Subject: AP1000 COL Responses to Requests for Additional Information (TR 85)

Responses to Requests for Additional Information on Technical Report No. 85

RAI Response Number: RAI-TR85-SEB1-04
 Revision: 0

Figure 2.6-1 NI05 Model with Soil Springs

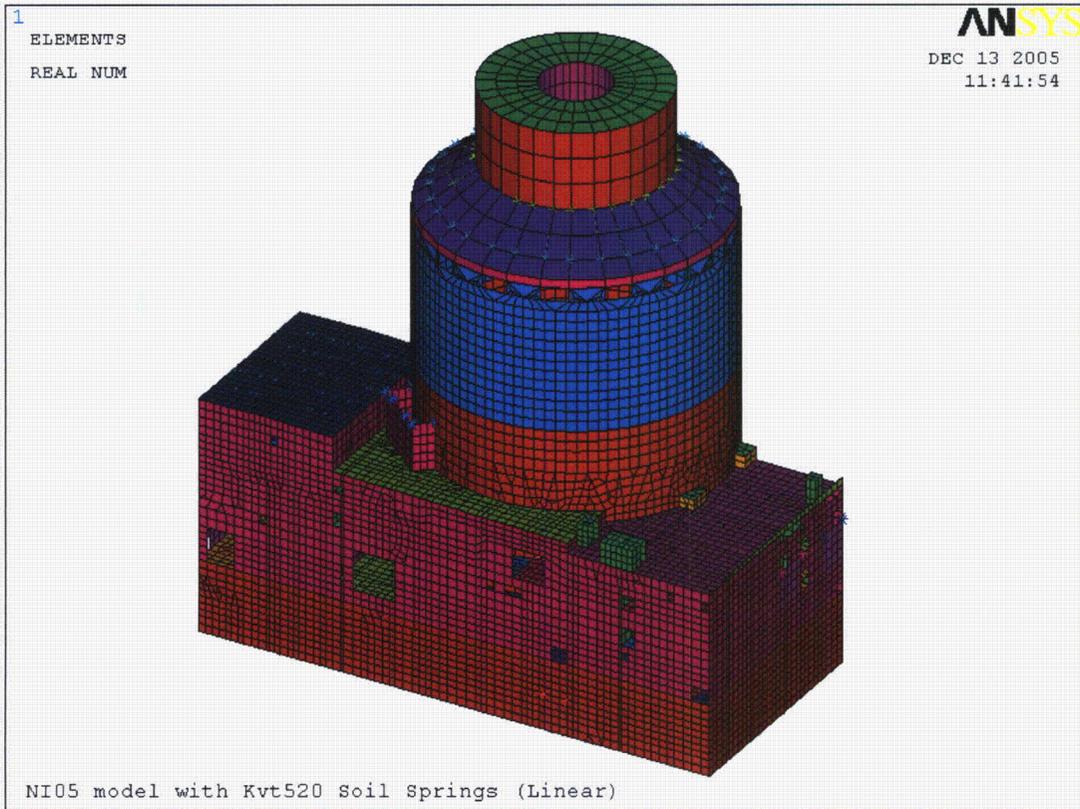
Section 2.6.1.2 indicates that the seismic loads for the evaluation of the basemat of the NI are developed from the results of the global seismic analyses as described in Section 6.2 of TR-03, Revision 0. The referenced report however, states that the set of equivalent static seismic accelerations used for the evaluation of the basemat and overturning stability are different than the acceleration values used for the design of the walls and floors of the building structures. The dynamic response of the structure affecting overturning and basemat uplift corresponding to about 3Hz on hard rock and 2.4 Hz on soil is utilized. The contributions from higher frequency modes are not considered. Based on this information address the following items:

The 3D ANSYS equivalent static nonlinear finite element model, used to evaluate the basemat and foundation walls, is the NI05 model described in DCD Rev 16 Appendix 3G, subsection 3G.2.3. The NI05 model is a large solid-shell finite element model of the AP1000 nuclear island which combines the ASB solid-shell model described in DCD subsection 3G.2.1.1, and the CIS solid-shell model described in DCD subsection 3G.2.1.2. Dead and seismic loads from the containment vessel and polar crane are applied as loads at elevation 100'. The nominal element size in the ASB portion of this NI05 model is about 4.5 feet so that each wall has four elements for the wall height of about 18 feet between floors. Views of this model are provided in Figures 2.6-1, 2.6-2 and 2.6-2 (a) thru (d).

Figure 2.6-2 (e) Basemat response spectra from SASSI analyses

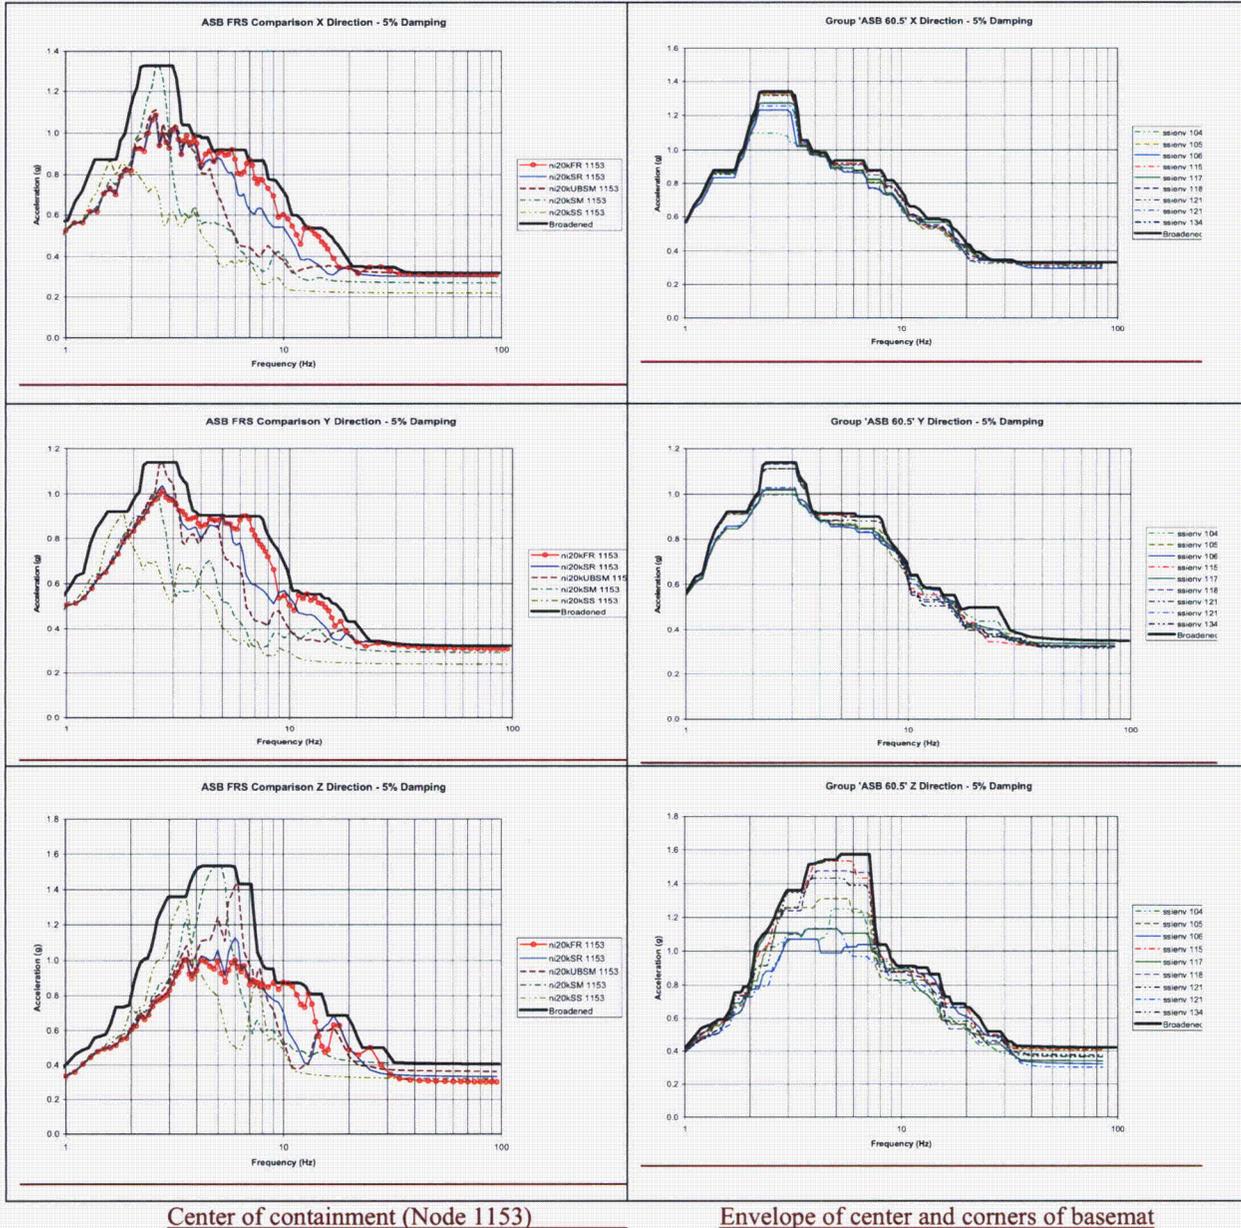
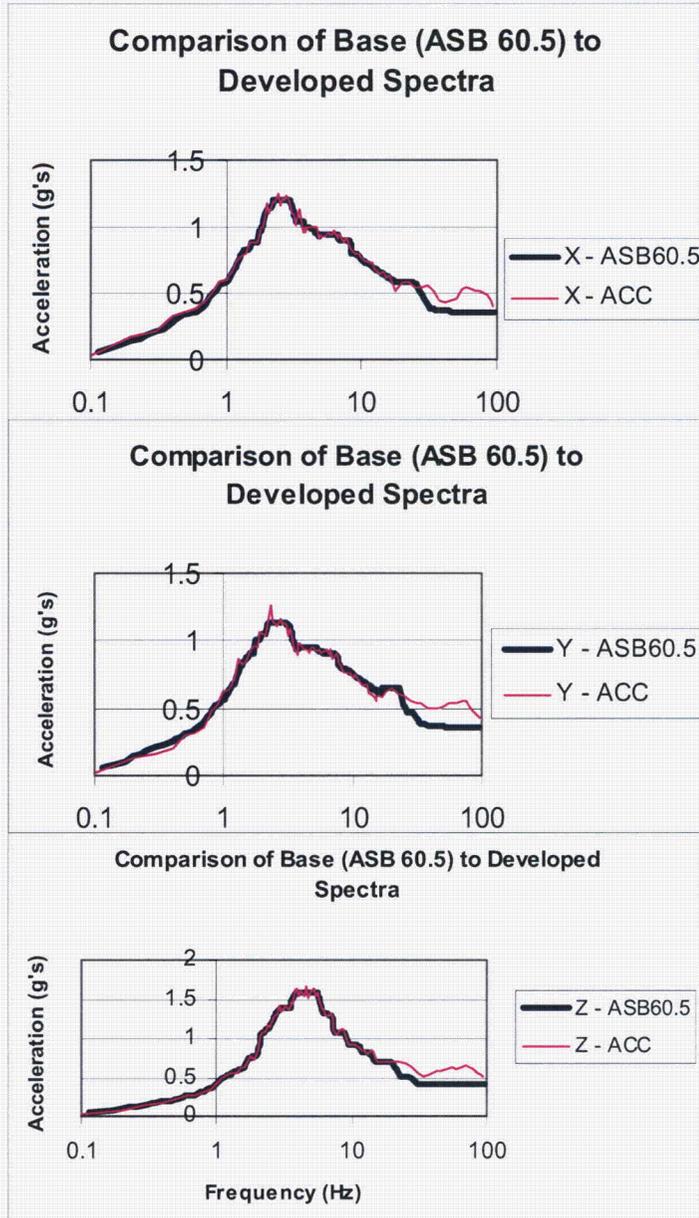
- a) The staff is concerned that this approach may not predict the true shear and overturning forces since some of the higher modes may also contribute to the forces imposed on the basemat and the foundation walls. Therefore, provide the technical justification for neglecting all modes above the fundamental mode of vibration, which may affect the design of the basemat and foundation walls as well as the sliding and overturning stability evaluation.

The equivalent static accelerations used in the non-linear design analyses of the nuclear island basemat were evaluated for the revised design with the enhanced shield building by comparing total base reactions and bearing pressures in a linear analysis using these equivalent static accelerations to those from a dynamic analysis of the updated nuclear island model (NI20). A time history fixed base analysis of the updated model was performed using time history inputs that envelope the basemat response given by the 3D SASSI analyses at the corners and centers of the basemat for all the specified generic soil cases. The

floor response spectra and broadened envelope at the center of the containment for the five soil cases analyzed in SASSI are shown in the left side of Figure 2.6-2 (e). The envelopes of the broadened spectra at the center and corners of the basemat are shown in the right hand side of the figure. The spectra for the time history developed enveloping these broadened spectra are shown in Figure 2.6-2 (f).
